CHANCE
MANUFACTURING CO., INC.

Service Information

Ride: TWISTER

INSTALLATION OF BELTS

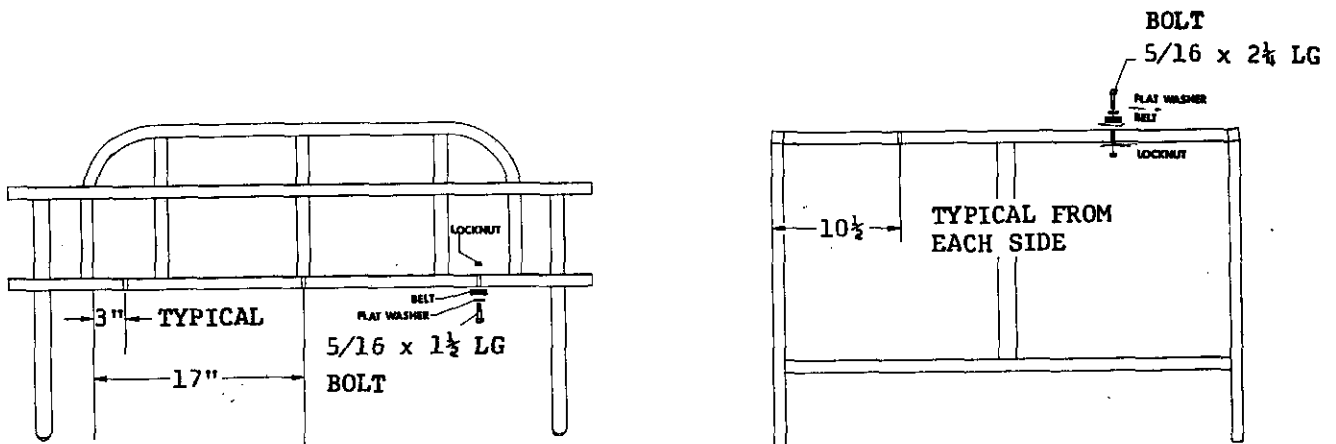
1. Remove the headrests from the cars and drill three 5/16" diameter holes in each one as shown.
2. Install 5/16 x 1½ LG bolt, flat washer and restraining belt from bottom side of tube on the headrest and secure with locknut.
3. Drill two 5/16" diameter holes down thru the square tube that supports the back of the front seat of each car.
4. Install 5/16 x 2¼ LG bolt, flat washer and restraining belt from top side of tube and secure with locknut.

When installing belts make sure they are not twisted before bolting.

DETAIL SECTION OF FLOOR LIFT BEAM

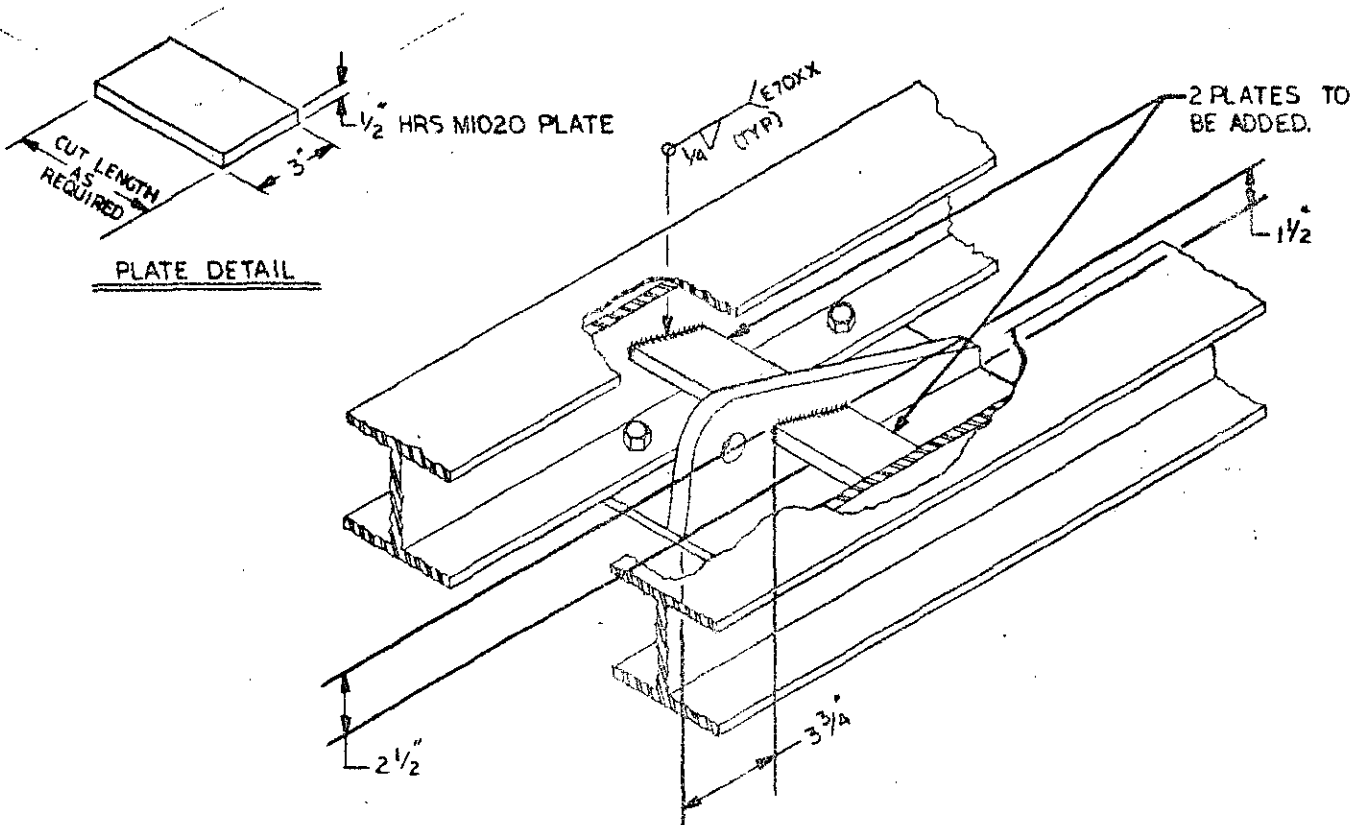
In order to improve the structure of the floor lift beam cylinder mounting bracket, we ask that the following change be added to both floor lift beams. Weld two $\frac{1}{2}$ " steel plates, one to each side of the hydraulic cylinder mount, in accordance with the dimensions shown in the detail section. Ride owner to furnish plates to be added.

Subject: Trailer Reinforcement

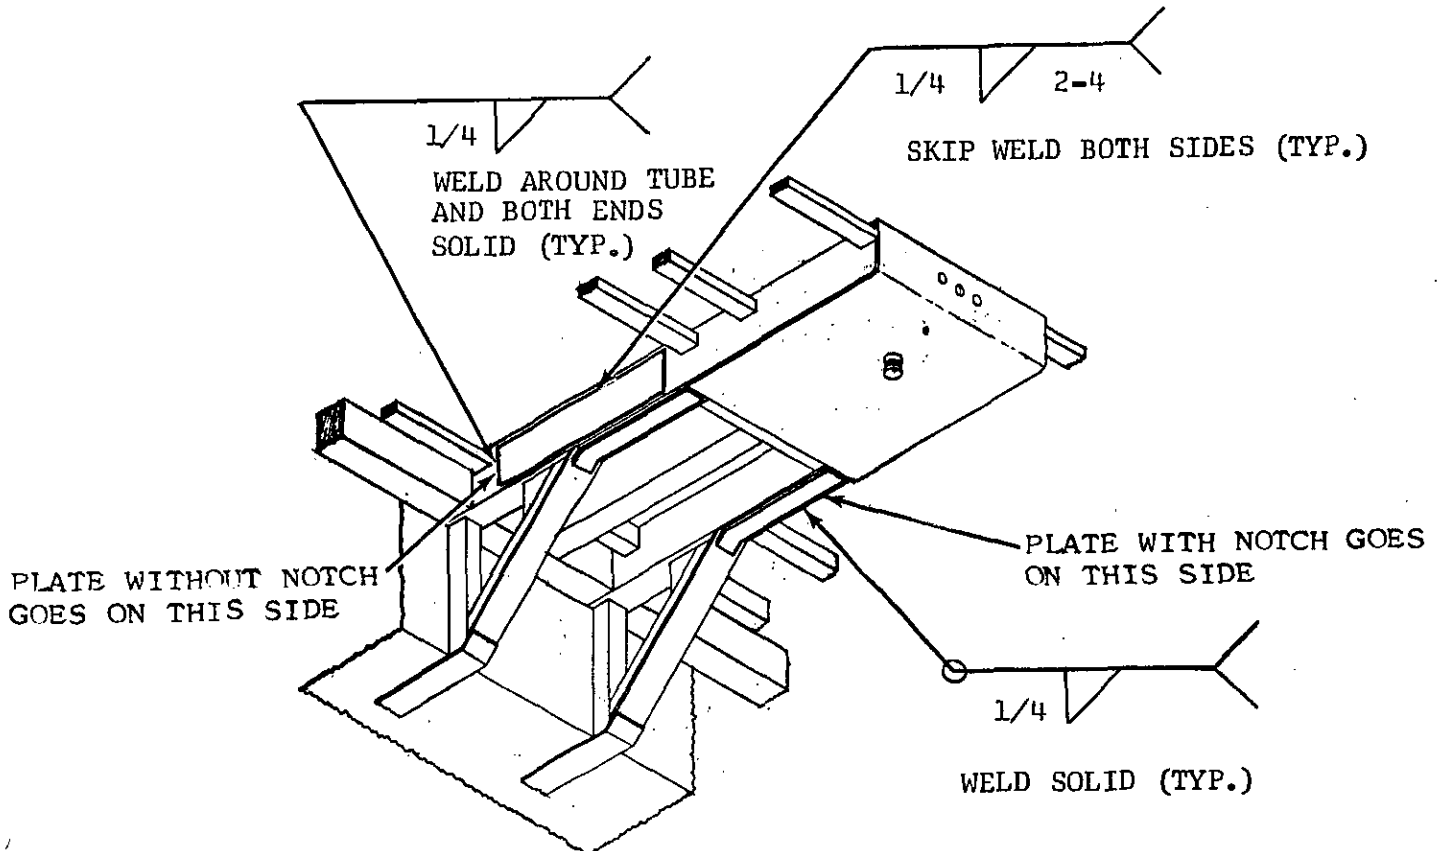
We wish to inform all Twister owners of an area on the Twister trailer that could be termed marginal as far as strength goes. Should the trailer become bogged in mud and you try to jerk it free, it is possible that the main support tubes could bend. This could also happen if the trailer were bouncing severely on a rough highway. Enclosed is a print showing details of some plates. We are recommending that these plates be added to the trailer immediately. The print calls for 3/8" thick plate and this is recommended. However, if the 3/8" plate is not available, 1/4" plate could be substituted.

Subject: HEAD REST INSPECTION

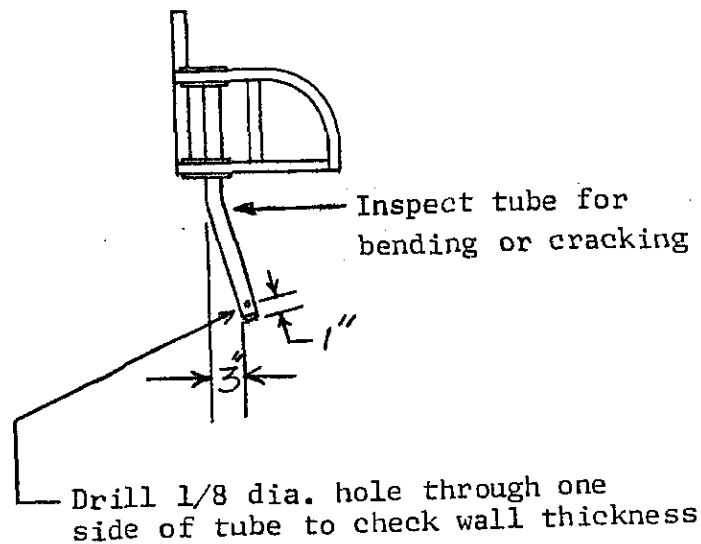
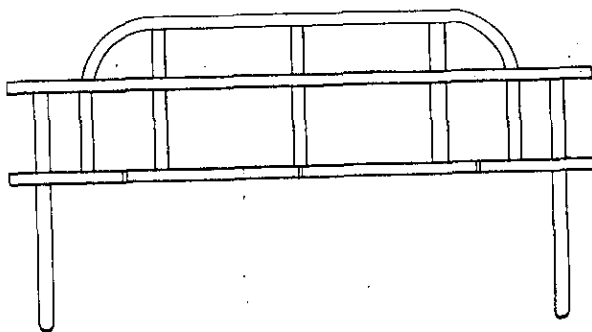
We are asking all TWISTER owners to inspect the head rests on all TWISTER cars immediately. Remove each head rest and inspect the support tubes that fit down in the sockets on each car. Inspect for any signs of physical damage, such as bending or cracking. Next, drill a small hole, 1/8 inch, near the bottom of the support tube approximately 1 inch from bottom. Drill hole through one side of tube only. Check wall thickness of tube. It should be 1/8 inch thick.

If any of the tubes show signs of bending or cracking, or if any tube has less than a 1/8 inch wall, report such condition to Mr. Richard G. Chance, General Manager, Chance Manufacturing Company.

Subject: INSTALLATION OF CONTROL
LEVER DETENT

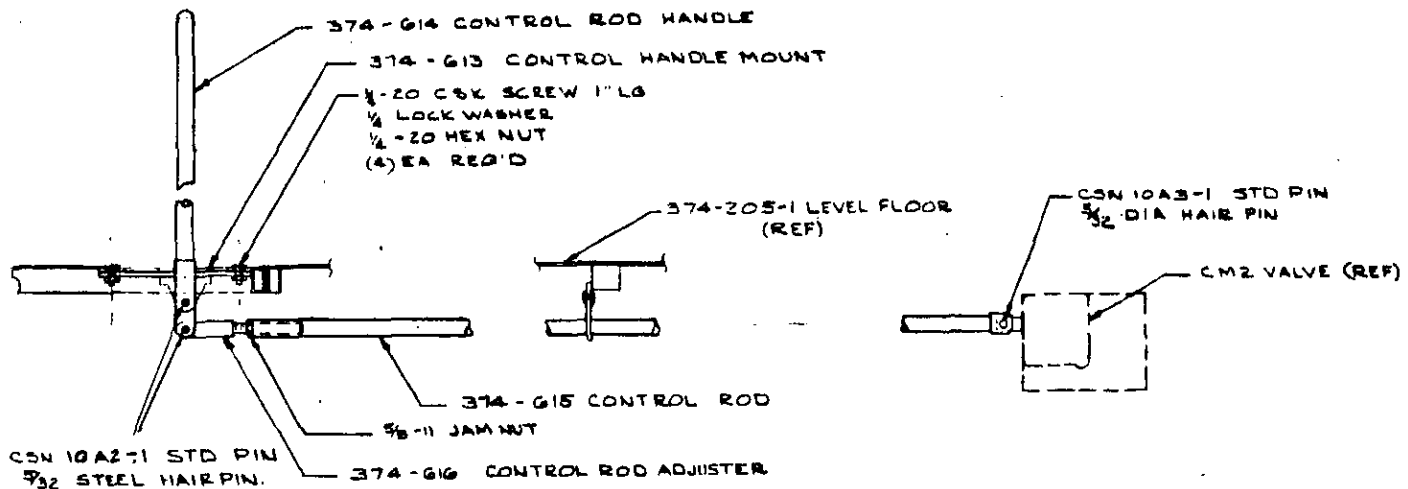
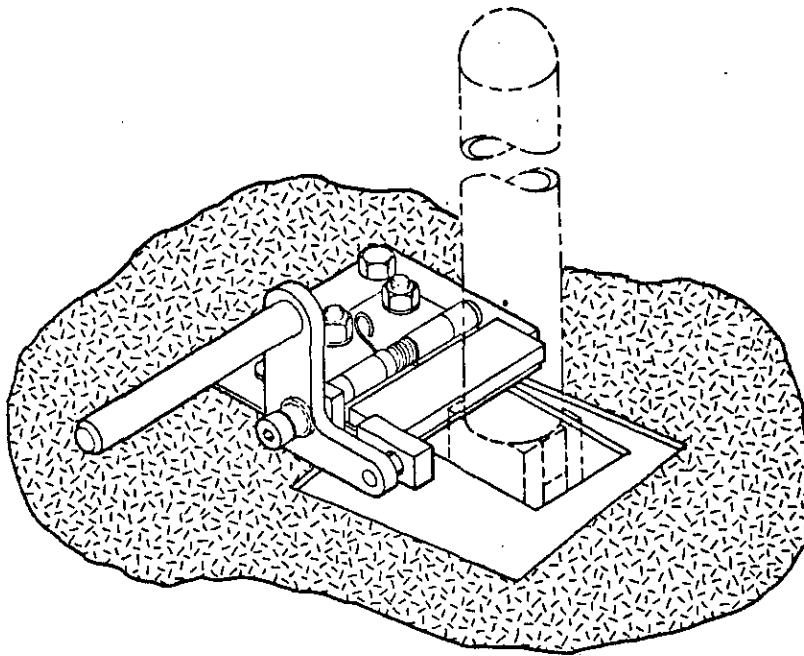
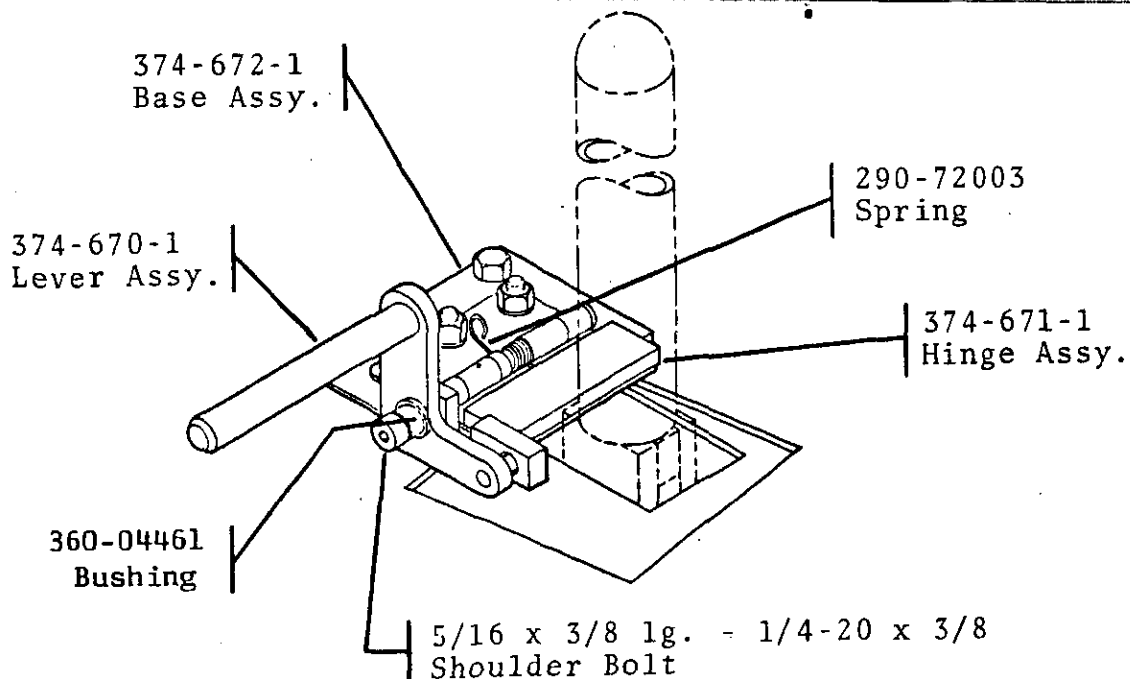
Before installing the detent, the Control Rod Handle should be adjusted so it is in a vertical position.

To adjust handle, loosen the jam nut and adjuster on the control rod underneath the porch. Turn adjuster until Control Handle is vertical and tighten jam nut.

Position Detent Assembly in front of the Control Handle, centering it with the travel of the Handle.

If there is any slop or play in the travel of the handle, push it forward gently until it is at the point of engaging the control valve.

Now, position the detent so that it is up against the Control Handle

Mark and drill holes to match Detent Base Plate, securing with bolts provided.

INSTALLATION OF SPRING

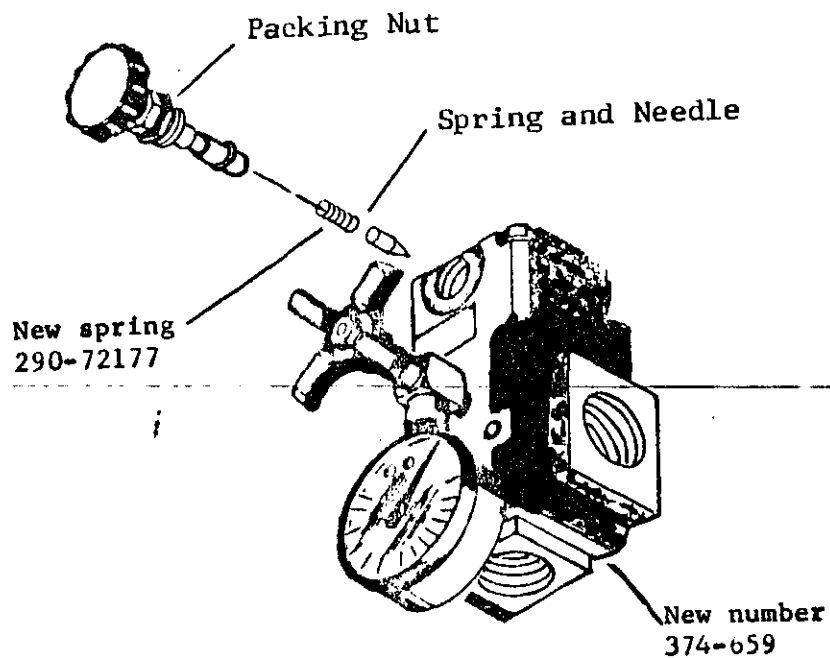
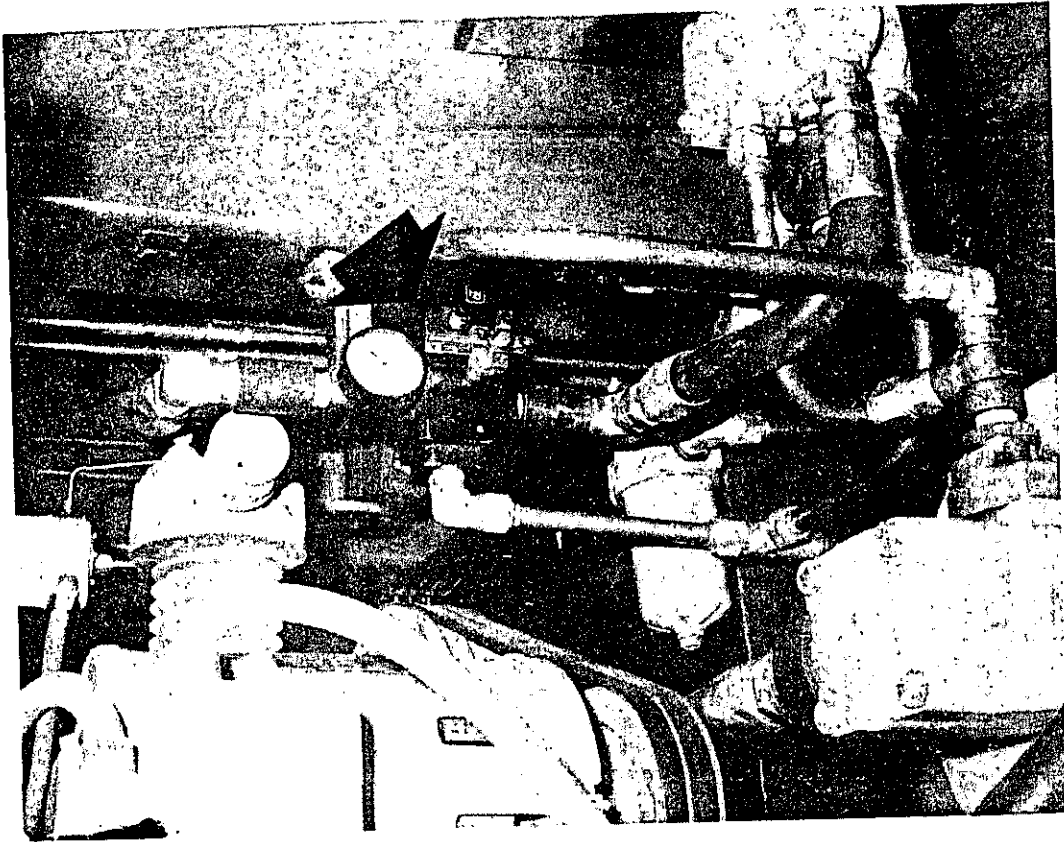
From field observations, it has become apparent that a number of TWISTER Rides are being operated with the "Brake Pressure Relief Valve" set at a higher pressure setting than the recommended 700 P.S.I. maximum.

This results in a severe braking action causing discomfort to ride passengers. In addition, it subjects the ride structure to undue stresses.

To eliminate this, we have enclosed a new spring that is to be installed in the relief valve. This will limit the valve to a maximum setting of approximately 700 P.S.I.

The Relief Valve is readily accessible as can be seen in photograph.

To replace spring, loosen the packing nut behind the Adjustment Knob, and carefully remove Adjustment Knob and Stem.

Replace spring and assemble in reverse order.

Run the ride and adjust Relief Valve to approximately 600-700 P.S.I.

Subject: CHECKING SWEEP FOR CRACKS

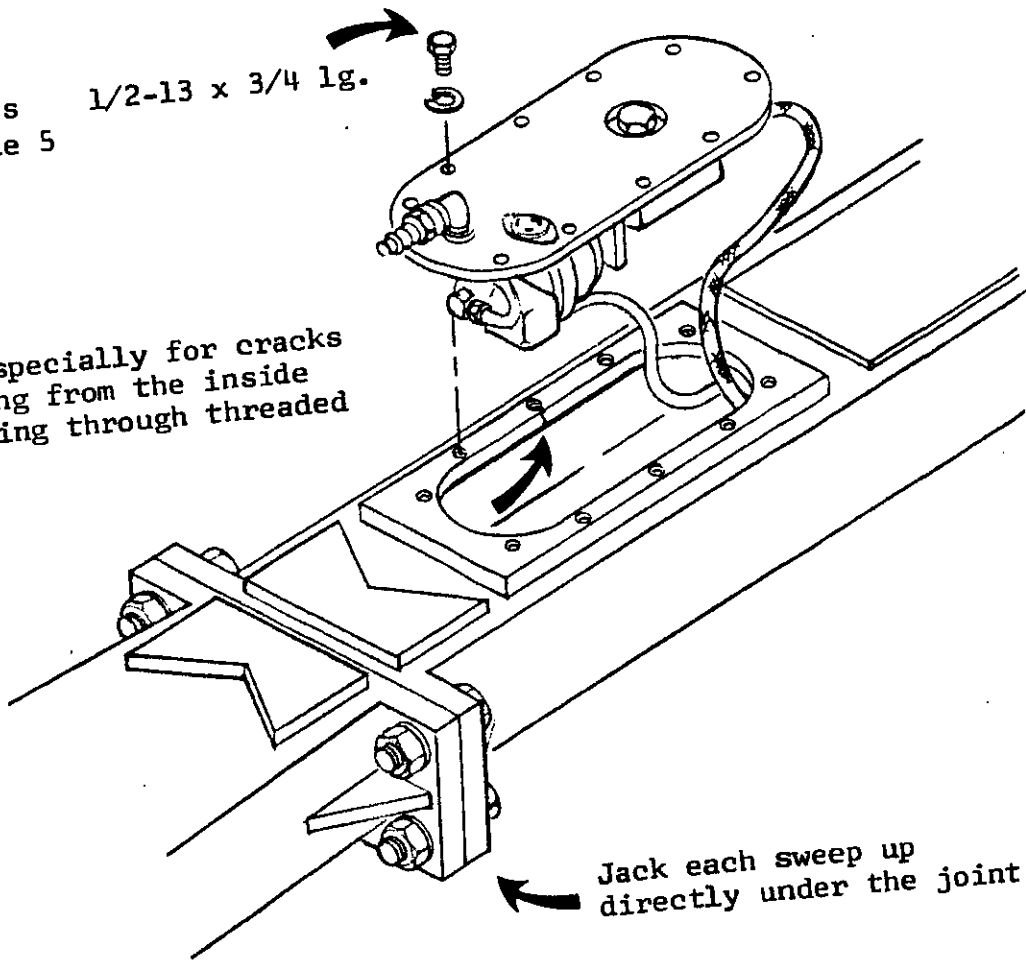
One of the Outer Sweeps on a TWISTER has developed a crack in it. The crack developed across the top side starting from the access hole for the Master Cylinder. This has only shown up on one sweep and could be attributed to any one of several possible causes.

However, the most logical cause for the crack is simply that the cover plate was not bolted down tightly.

Look especially for cracks starting from the inside and going through threaded hole.

If no cracks are found, install cover plates, torquing bolts to 75 ft. lbs.
If bolts are greasy or oily, torque to 55 ft. lbs.

Check length of bolts before installing cover plates. The six bolts along sides should be 3/4 inch long grade 5 bolts. Longer bolts will bottom out against the sweep channel not drawing the cover plate down tight.

SECTION A-A

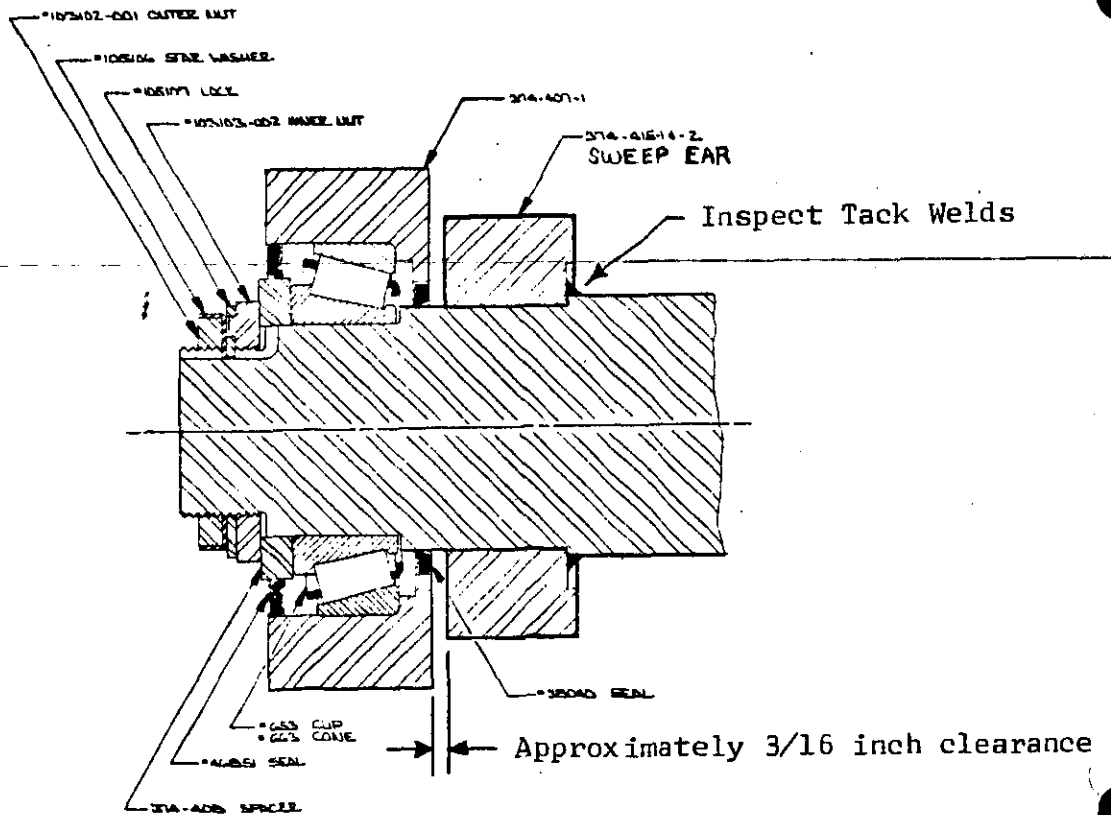
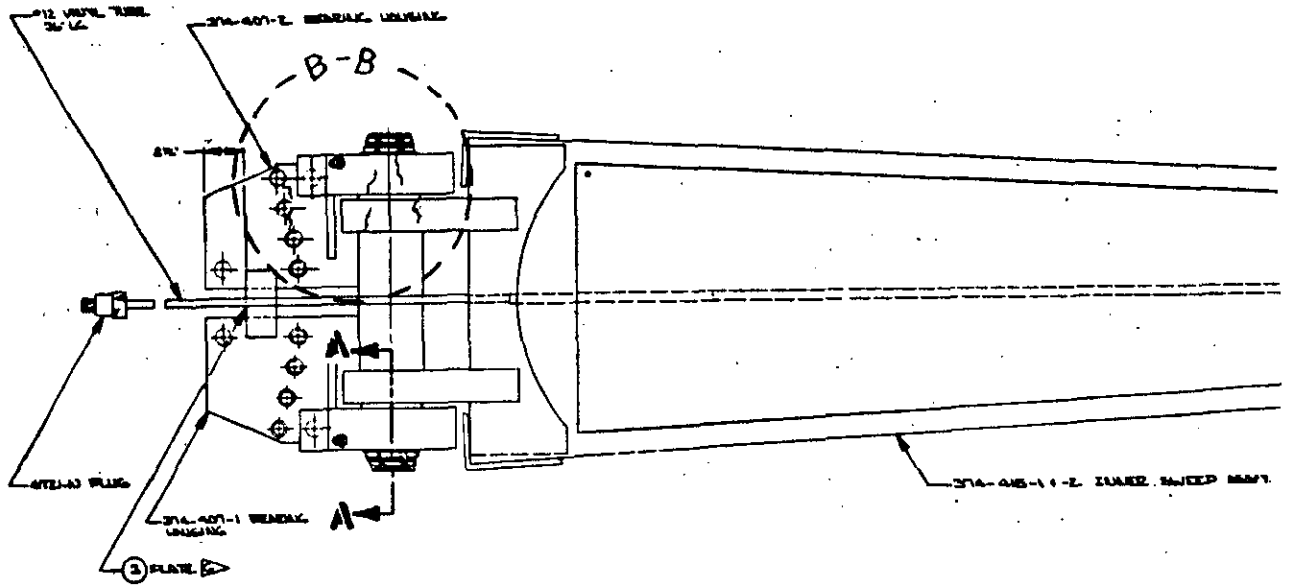
1. Inspect the plate and ears that bolt onto the Center Hub, paying particular attention to the area around the bolt holes. "B-B" and ears that house the Bearings shown in section "A-A".

2. The sweep shaft is tack welded to the sweep ears as shown in "A-A". Inspect this area very carefully to see if welds are holding.

Also, check clearance between sweep ear and the bearing ear. There should be approximately 3/16 inch between the ears.

Subject: SWEEP REPORT

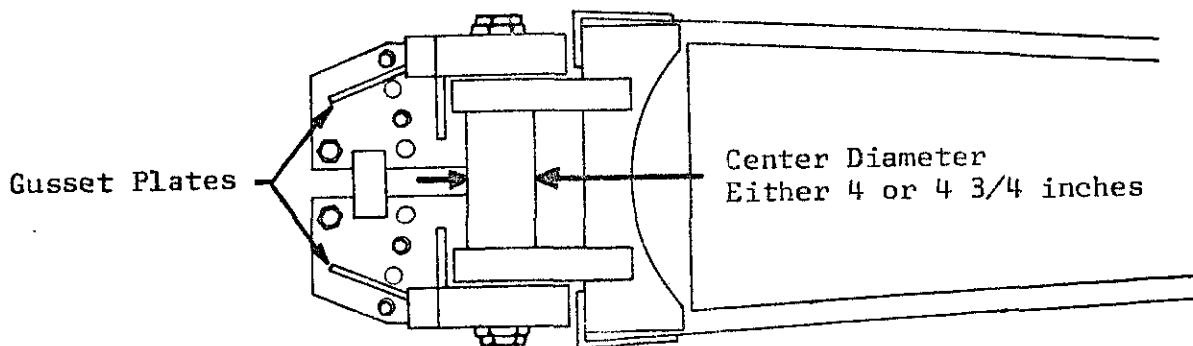
After evaluating the reports on the Sweep joints, Ref. Bulletin 104, it has been determined that it would be desirable to reinforce all existing sweep joints, that haven't already been done.

1. Center diameter of shaft.
2. Bearing housing (does or does not) have gusset plates as shown.
